EIS IDENT: SHROUD STABILIZER HARDWARE

DOCUMENT TITLE SHROUD STABILIZER HARDWARE

TYPE: DESIGN SPECIFICATIONFMF: PEACH BOTTOM 2 AND 3MPL NO: PRODUCT SUMMARY SEC. 7

**GE RESPONSES
TO NRC QUESTIONS
FOR
PEACH BOTTOM SHROUD REPAIR**

Figure 1. Peach Bottom Shroud / Stabilizer ASIST Model Definition

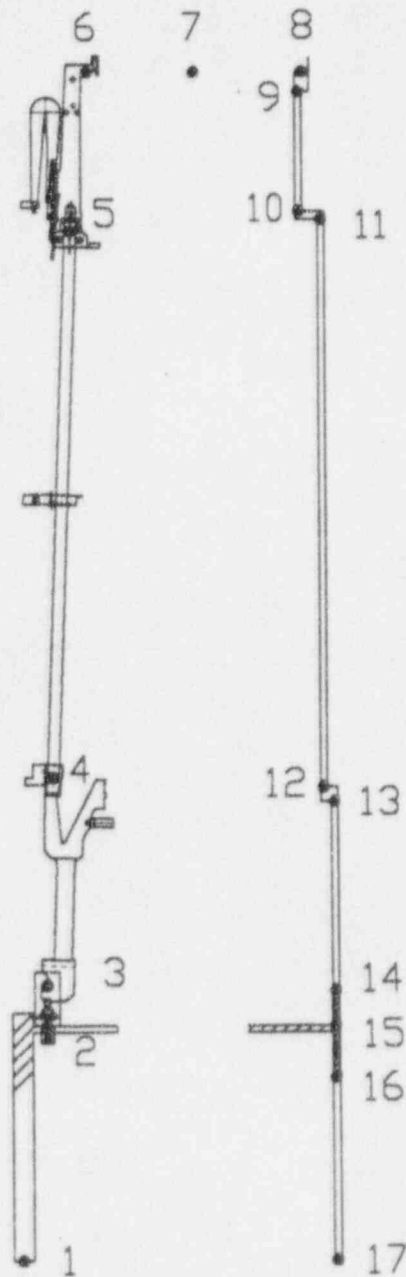
This section presents a description of the analytical model and the inputs to the model which produce the axial load distributions in the stabilizer assemblies and shroud for the cases of normal operation with normal temperature and pressures and the case of a thermal transient with the corresponding temperature and pressures. The model is schematically shown in Figure 1. The model consists of a system of collinear two-dimensional beams, each beam representing the length and stiffness of a major component of the stabilizer assembly and shroud. Direct inputs to the beam elements of Modulus of Elasticity, coefficient of thermal expansion, temperature, distributed axial loading and point loads appropriately addressed the effects of component stiffness, temperature differences, pressure differences, component weights and mechanical preload of the tie rods. The ASIST computer program was used to solve the system of beam elements and produce the resulting load distributions.

Figure 2. Peach Bottom Shroud / Stabilizer
ASIST Model Axial Stiffness Values

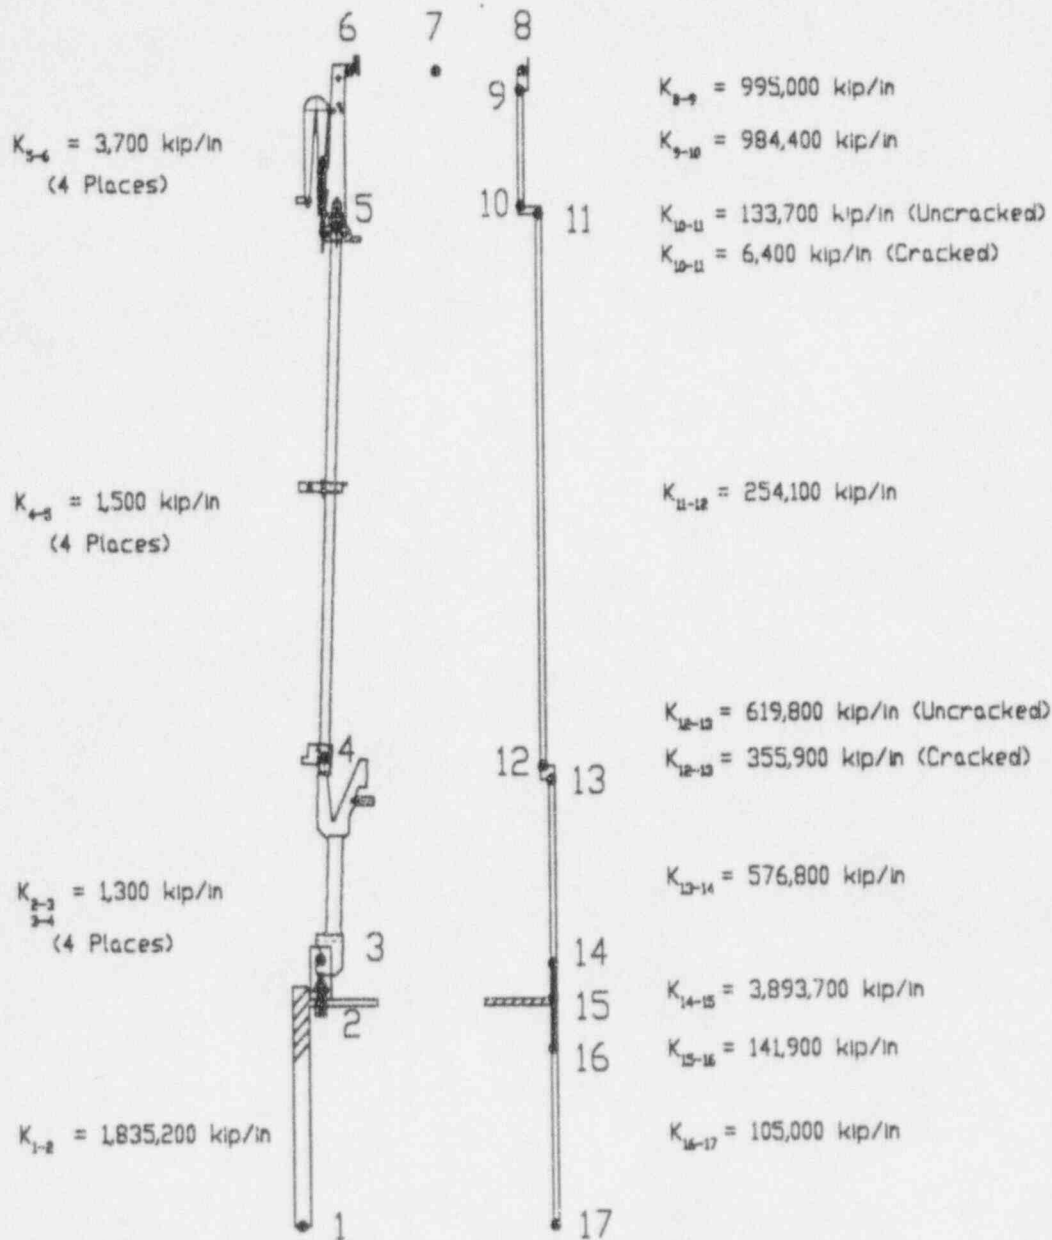
The axial stiffness of the lower stabilizer spring assembly and the upper support assembly were determined by finite element analysis. The tie rod axial stiffness was determined by a simple hand calculation of a beam in tension. The values used are shown in Figure 2.

The axial stiffness of the shroud was determined by a combination of finite element analysis and theoretical ring stiffness calculations. The axial stiffness of the shroud shell members, shroud support ring and struts were determined by finite element analysis. The resulting axial stiffnesses are shown in Figure 2.

The axial stiffness of the shroud shell to ring welded connection was determined using the method of analysis and equations from Section III, ASME B&PV Code, 1965 Edition, Appendix I, Article 1-2. This method was used for the ring axial stiffness between welds H2-H3 and H5-H6. The stiffness was determined for both the case of intact welds and fully cracked welds. The fully cracked welds were assumed to be through wall at the top of the weld fillet as schematically shown in Figure 3. Values of the axial stiffnesses used for the cracked and uncracked condition are shown in Figure 2.
